Service Letter No. 404

SUBJECT: Inspection of Altimatic and Altimatic II Pitch Servo Assembly Chain Adjustment Screw

MODELS AFFECTED: PA-23 Apaches, Serials 23-1502 to 23-2046 inclusive
PA-23-250 Aztecs, Serials 27-1 to 27-504 inclusive
PA-23-235 Apaches, Serials 27-505 to 27-572 inclusive
PA-23-250 (6 place) Aztecs, Serials 27-2000 to 27-2388 inclusive
PA-24 and PA-24 "250" Comanches, Serials 24-2003, 24-2203, 24-2299 to 24-3557 inclusive

SERVICE LETTER NO 404

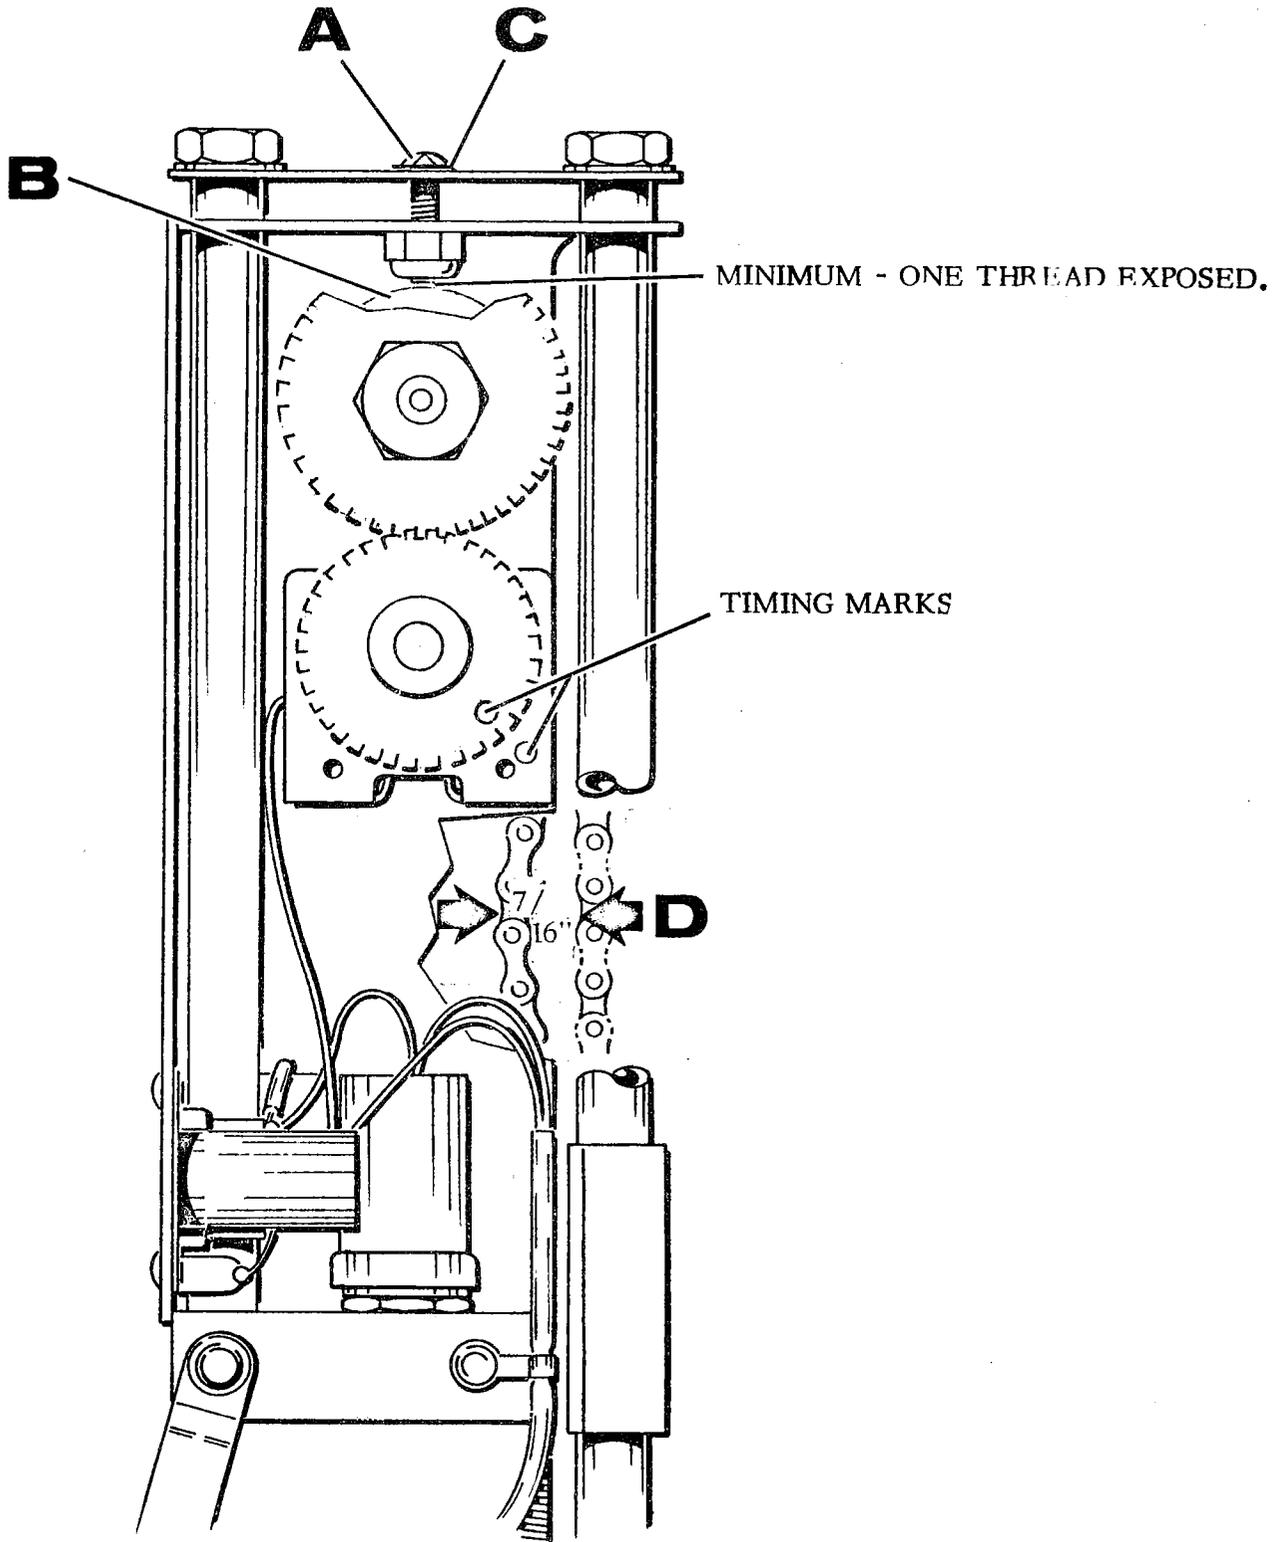
In order to provide a positive lock of the screw, at least one or more threads must protrude through the nut. If this cannot be accomplished without maladjustment of the pitch servo chain tension, (See pitch servo chain adjustment procedure on the following page.) it will be necessary to remove the screw and replace it with a "long-lok" type screw (Mitchell part number 3S275). Standard AN 1/32" thickness washers may be used as required under the head of the screw to prevent driving the screw end against the adjacent sprocket mounting.

1. Completely disengage the servo.
2. Measuring on the opposite side of the slide bushing or break-away link in the center of the servo, the chain should have approximately 7/16" slack.
3. By turning the adjusting screw clockwise, the chain tension is increased and by turning counter-clockwise, the chain tension is decreased.

See sketch attached to this letter for screw location and chain adjustment details.

IF LONG-LOK SCREW (A) CONTACTS SPROCKET MOUNTING (B), REMOVE SCREW AND INSTALL PACK WASHERS (C), UNDER HEAD OF SCREW AS REQUIRED TO MAINTAIN CHAIN TENSION OF 7/16" SLACK (D).
